<b>Office Action Summary</b>	<b>Application No.</b> 10/786,310	<b>Applicant(s)</b> OTOHATA ET AL.
	<b>Examiner</b> JULIAN MERCADO	<b>Art Unit</b> 1795

**DETAILED ACTION**

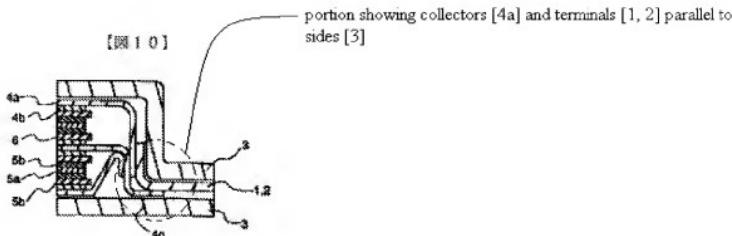
This rejection is maintained for the reasons of record. Regarding the present amendment to independent claim 1, firstly the examiner notes that the limitations of claim 2 (now canceled) have been incorporated into claim 1. Secondly, for the reasons set forth under 35 U.S.C. 112, first paragraph (discussion above) and to the extent that the claims are believed enabled by applicant's disclosure, in JP '825 positive and negative charge collectors [4a] are a collective joining of corresponding tabs to the positive and negative electrodes. All of Figures 1-3, 5, 6 and 8-11 show that the electrodes are joined in the thickness direction. The terminals [1, 2] are positioned between and parallel to the first and second side of the battery element. This configuration may be appreciated from Figure 10, appended herein:

Applicant's arguments filed with the present amendment have been fully considered, however they are not found persuasive. Applicant submits that in alleged contrast to JP '825, the present invention has its charge collectors and lead terminals parallel to the sides of the battery element. This alleged distinction is not persuasive, as Figure 10 of JP '825 shows the charge collectors [4a] and terminals [1, 2] also in parallel to the sides [3] of the battery.
